Montgomery Planning
EDGEMOOR
ADMINISTRATIVE SUBDIVISION PLAN NO. 620230060

Administrative Subdivision Plan to create up to two lots for single-family dwelling units; one for the existing dwelling unit and a second for the construction of a new dwelling unit.

No. 620230060

July 13, 2023

Figure 4 – Plan of Subdivision

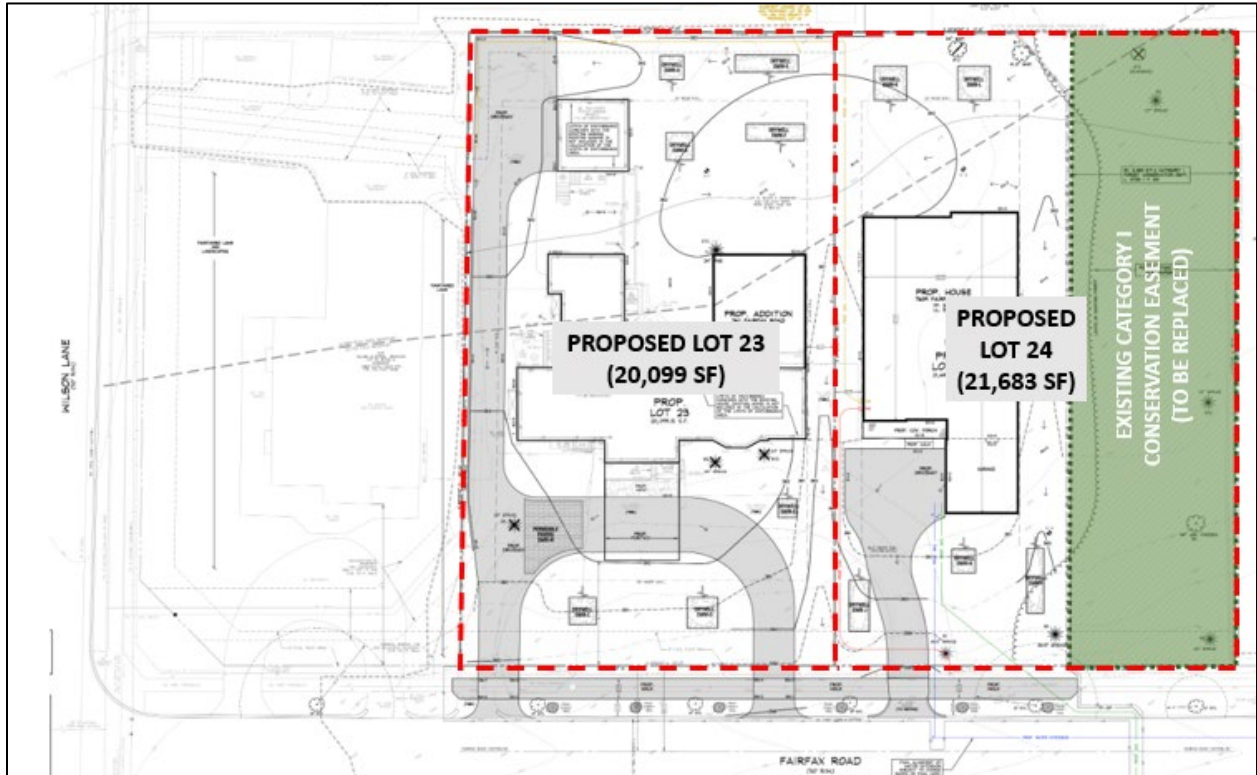
The existing home has a circular driveway that as conditioned, will be replaced with a single curb cut, which reduces conflicts with traffic on the adjacent road, as well as pedestrians and cyclists along the Site frontage. Both lots will be provided with a single driveway that complies with the standards of Montgomery County - Maryland Driveway Construction Policy.

Pedestrian access will be improved by widening the existing four-foot sidewalk with a six-foot sidewalk buffered by a five-foot tree-lined street buffer. The sidewalk will extend across both Site frontages on Fairfax Road, except the portion of Lot 24 which is subject to an existing Forest Conservation easement.

- b. Include the approved Fire and Rescue Access plan in the certified set.
 - c. Revise plans to show only one driveway per lot; remove the circular driveway shown on Lot 23.
